Solicitation Addendum

Addendum No.: 1
Solicitation No.: IFBC No. 24-TA005325JH
Solicitation Title: Satellite Lift Station R&R Upper Manatee River Road, 2024 Group 1 and Group 2
Addendum Date: June 20, 2024
Procurement Contact: Jeb Hayter, Procurement Agent III

SATELLITE LIFT STATION R&R

28-A, RTU 130

SHEET 04 OF 10

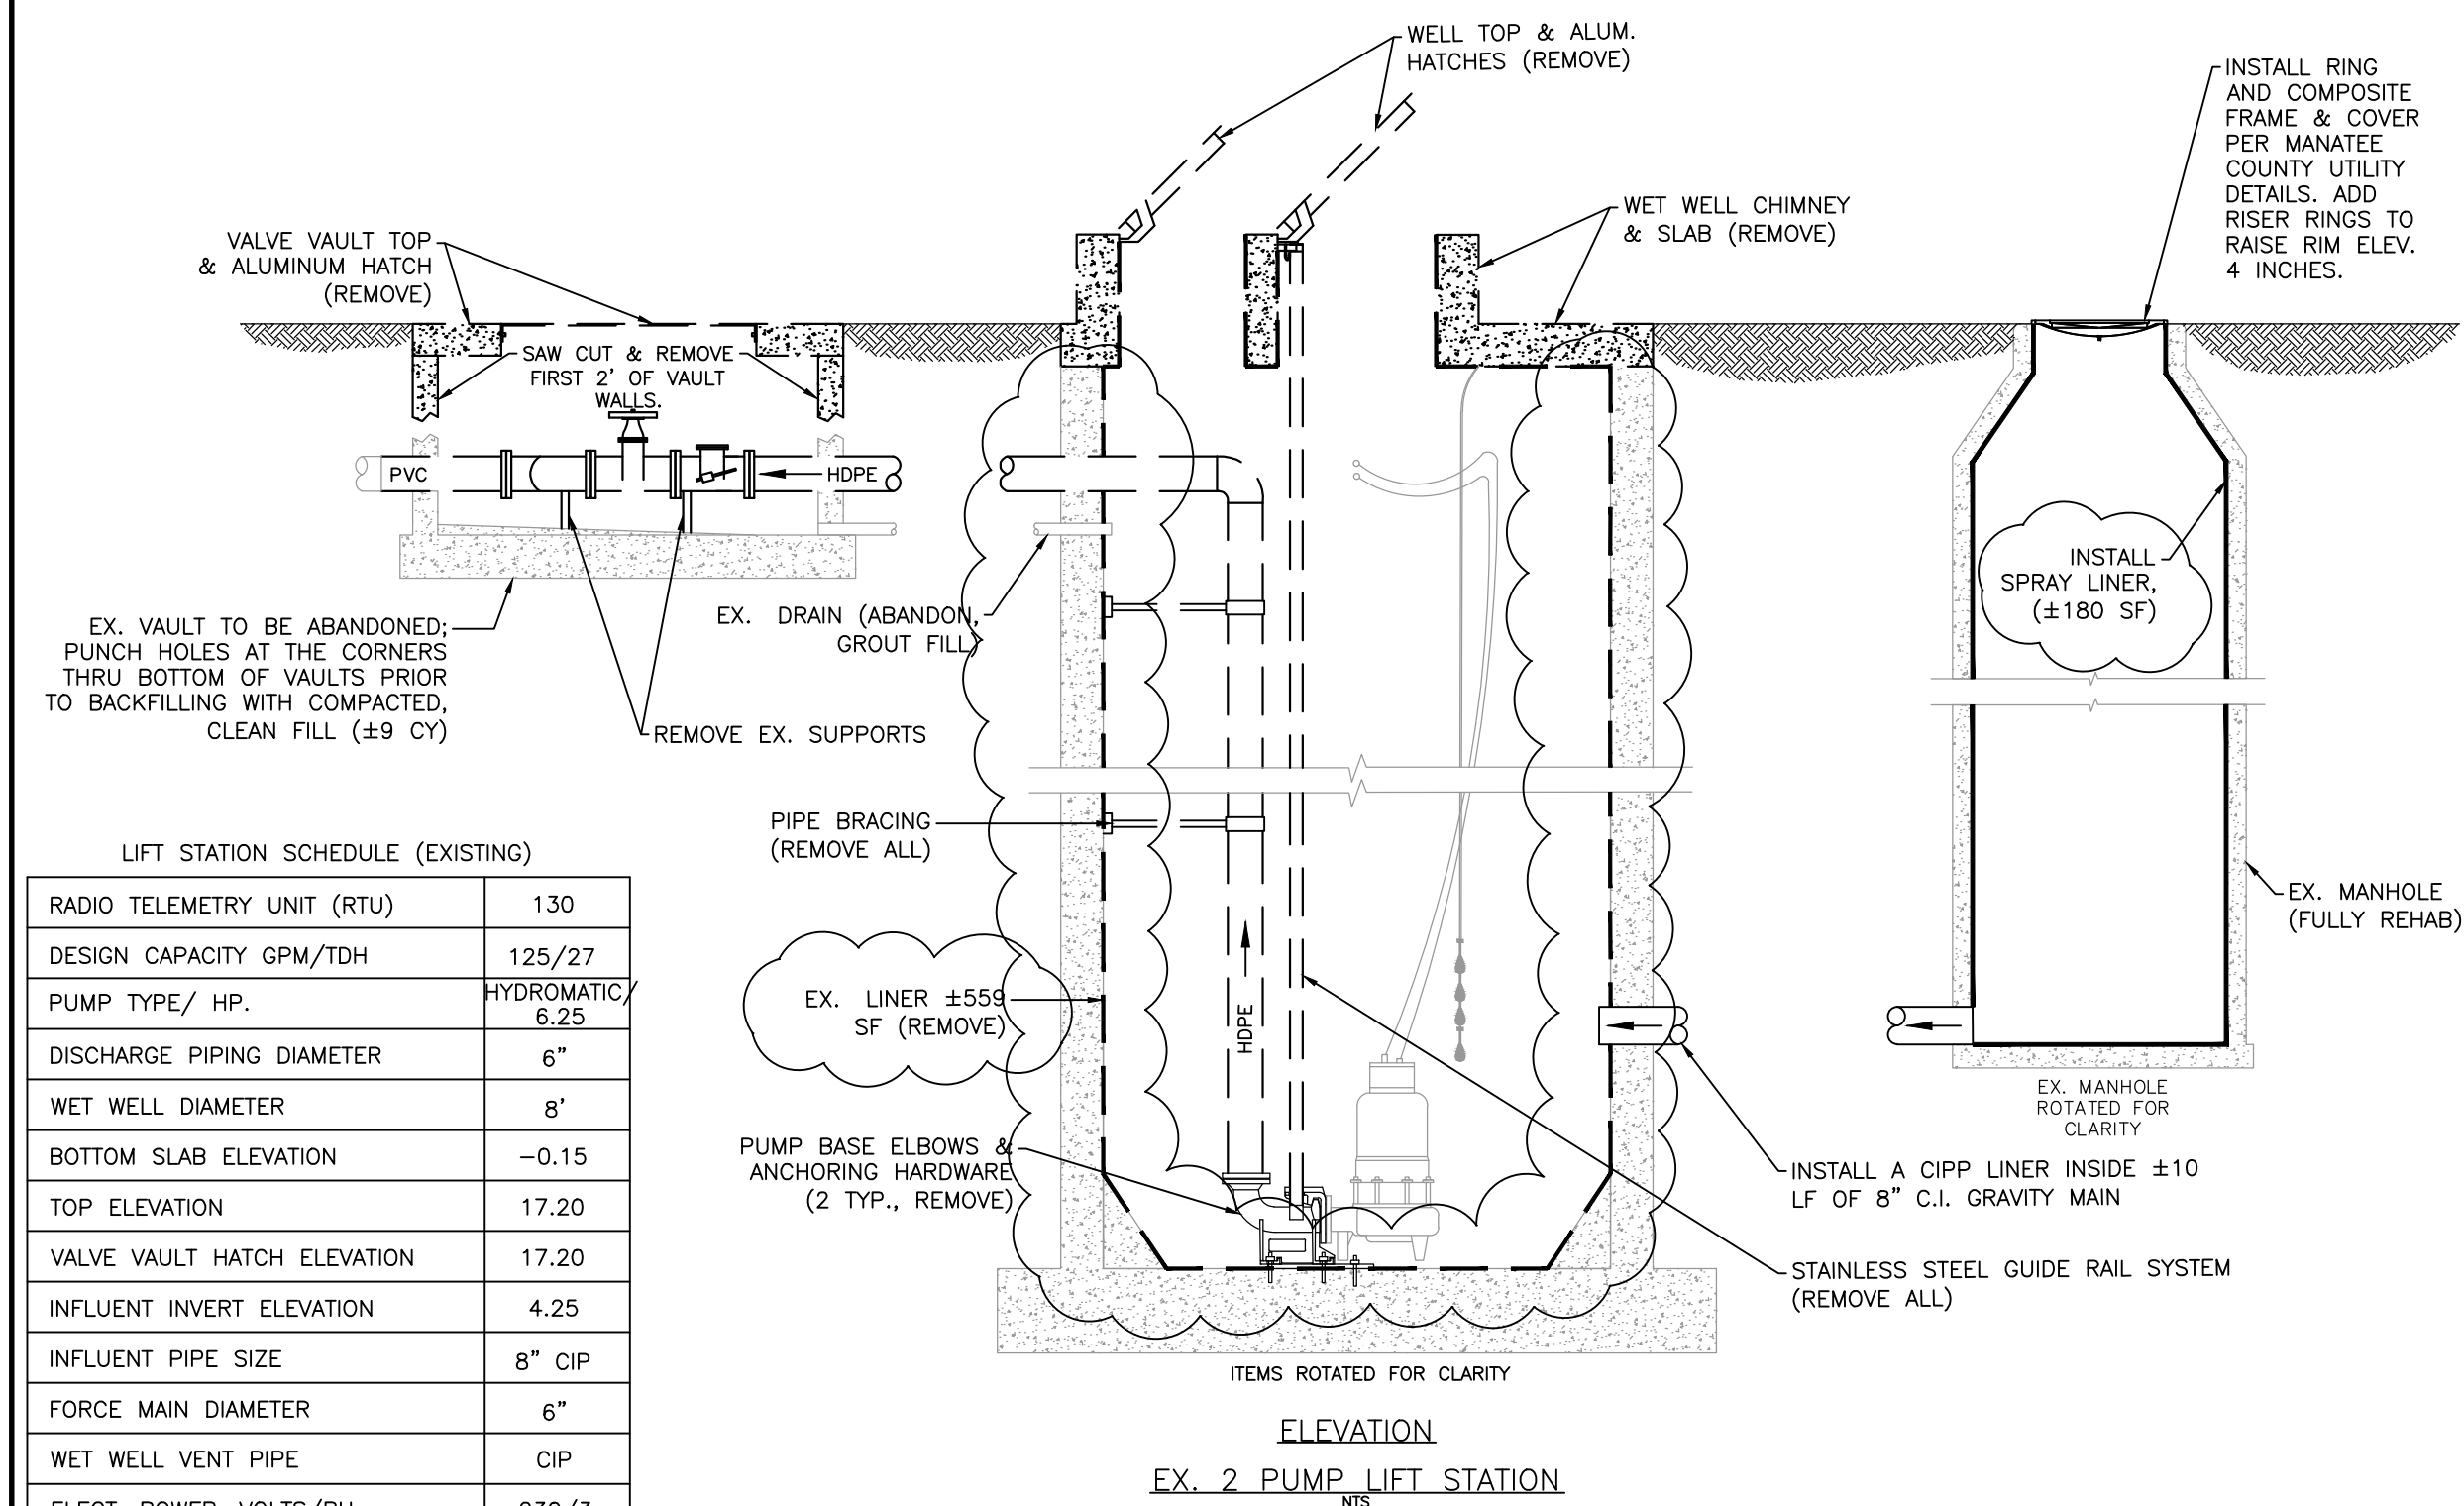
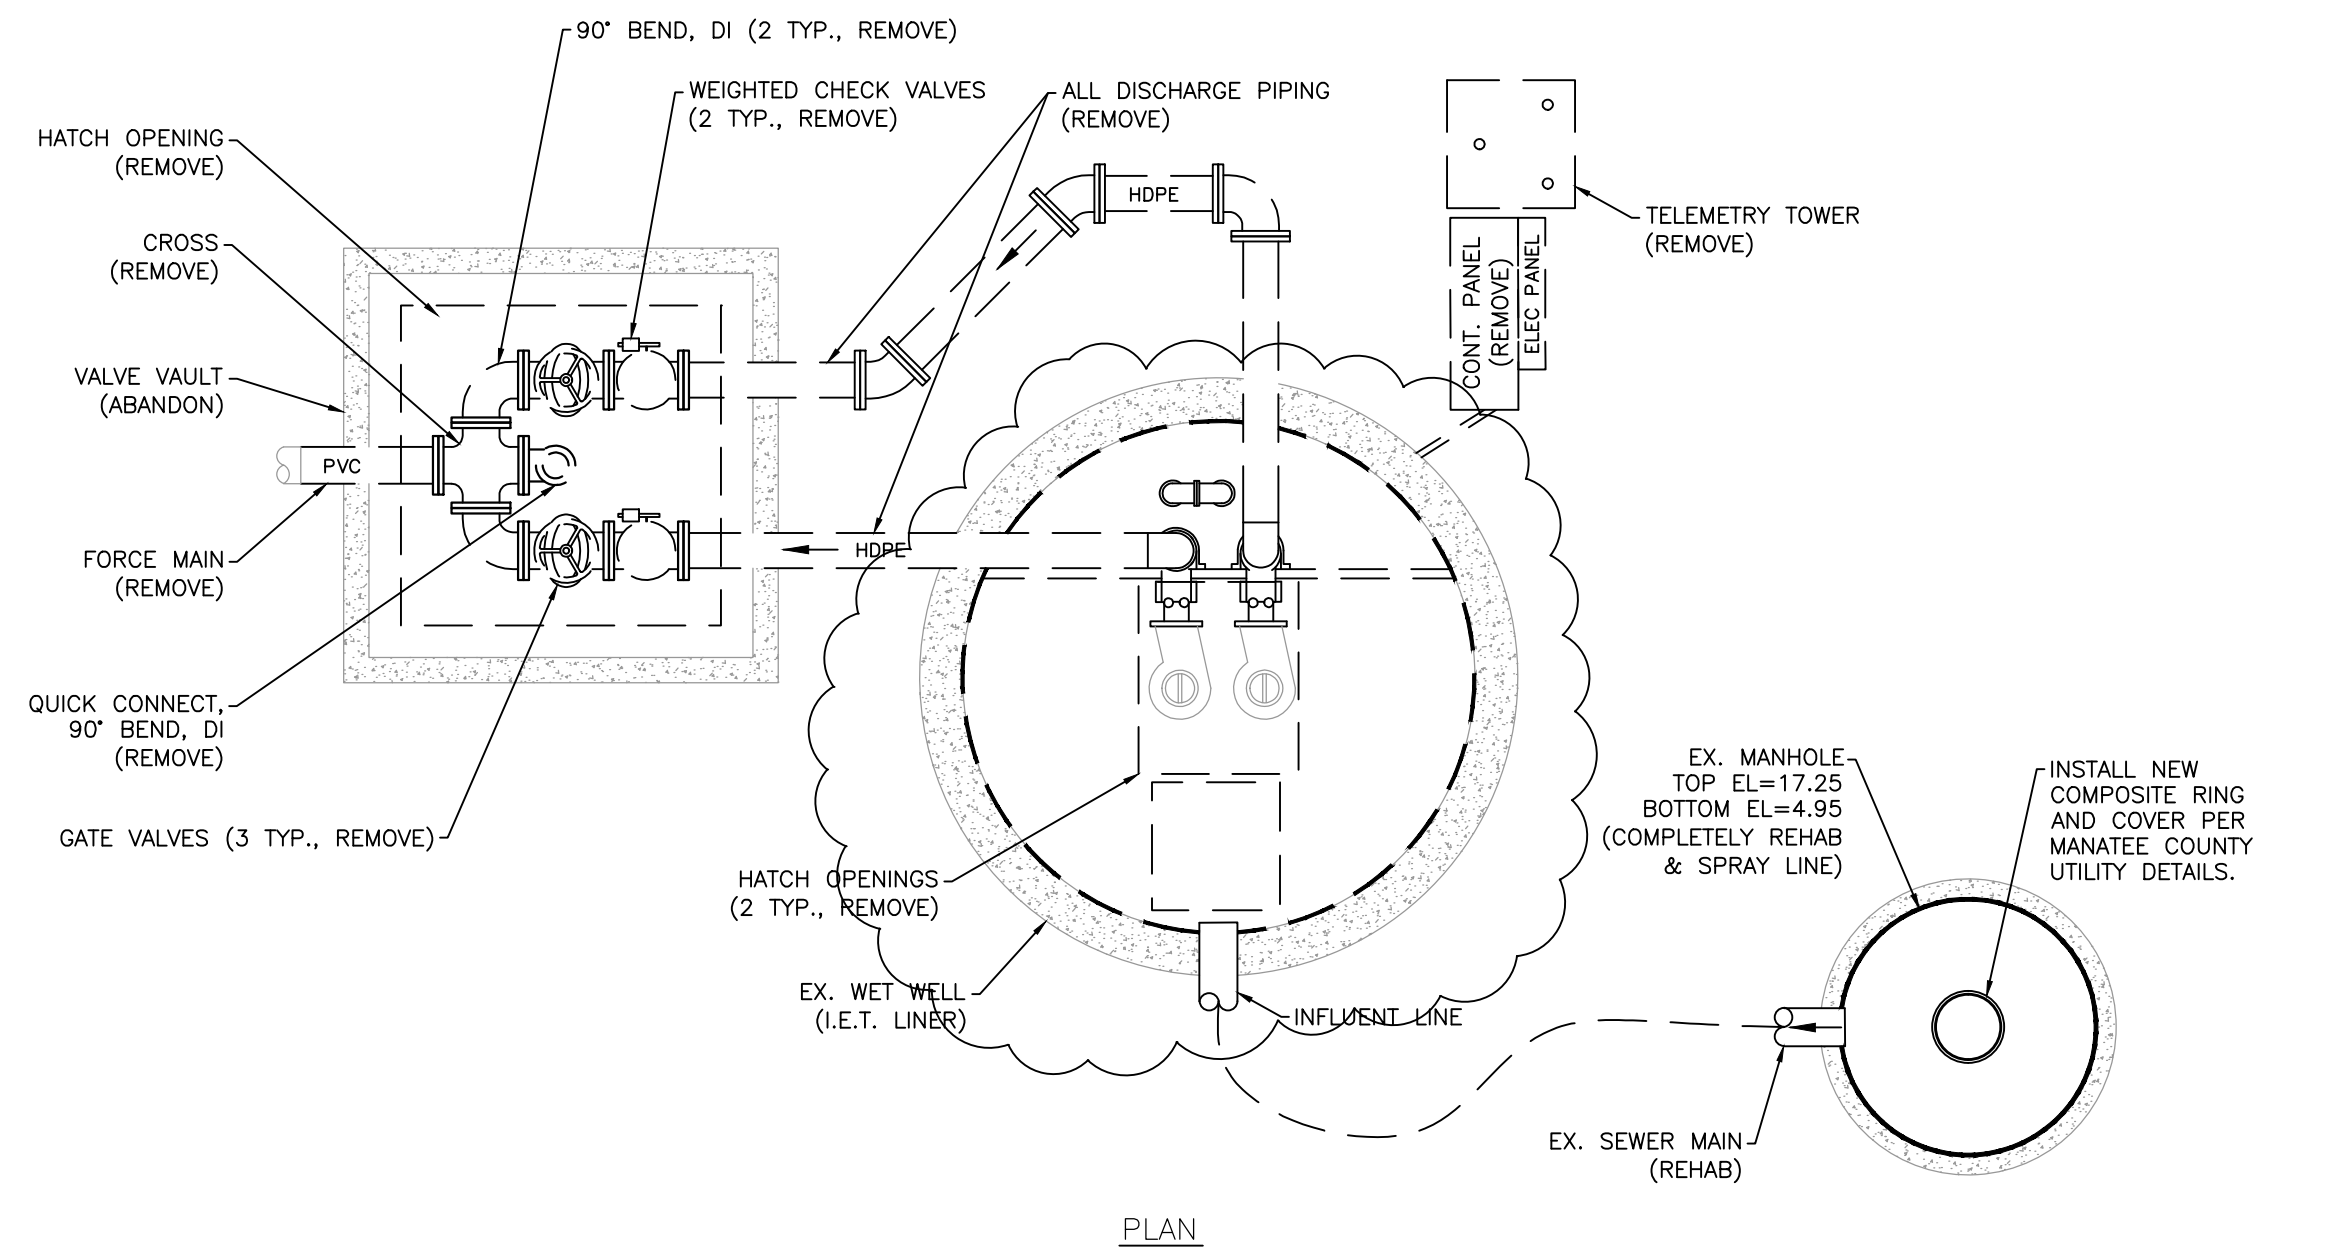
- Q12. 28-A RTU 130 states to use a County approved coating compatible with IET. Per my knowledge, there is no County approved coating that is compatible with IET? We suggest a full removal of the existing coating and full installation of a County approved coating, please advise.**
R12. The lift station has been modified to have the existing liner completely removed and an approved spray liner to be applied.

NO.	REVISION DESCRIPTION	BY	DATE
1	revised to completely remove existing wet well liner; revised manhole liner quantity	jss	6/18/24

INSTALL FIBERGLASS W.W. LINER	NO
APPLY SPRAY LINER W.W. LINER	YES
INSTALL STILLING WELL	NO
INSTALL FORCE MAIN ISOLATION VALVE	YES
NEW HDPE DISCHARGE PIPING	YES, 4"
NEW BASE ELL	4" BPIU-14
MODIFY TOP OF WET WELL:	YES
MODIFY TOP OF VALVE VAULT:	N/A
INSTALL WET WELL VENT PIPE	YES
INSTALL NEW WATER SERVICE ASSEMBLY	YES
RELOCATE EX. WATER SERVICE ASSEMBLY	NO
